# Gamma Bracing Technologies Ltd

## Re: Positioning of Gamma Frames Within Walls

Figure 1: Original Design Layout

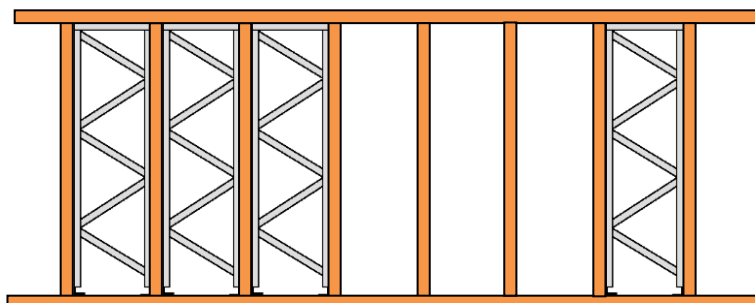
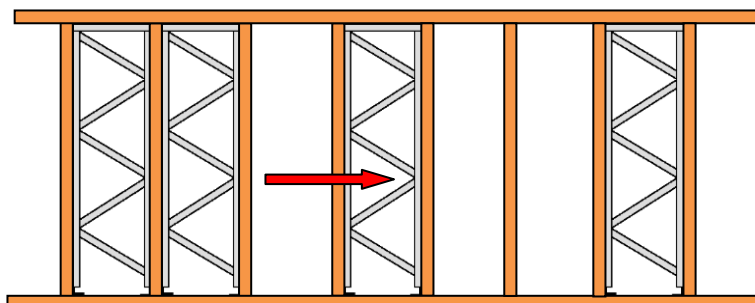
It is permitted to change the position of the Gamma Bracing Frames (GBF) within the wall framing. The same quantity of GBF's must be maintained as to not impede the structural performance requirements of the walls original layout. (See examples in Figure 1 & 2 below).

The GBF's must be installed as per the instructions detailed in the Gamma Bracing System Technical Manual.
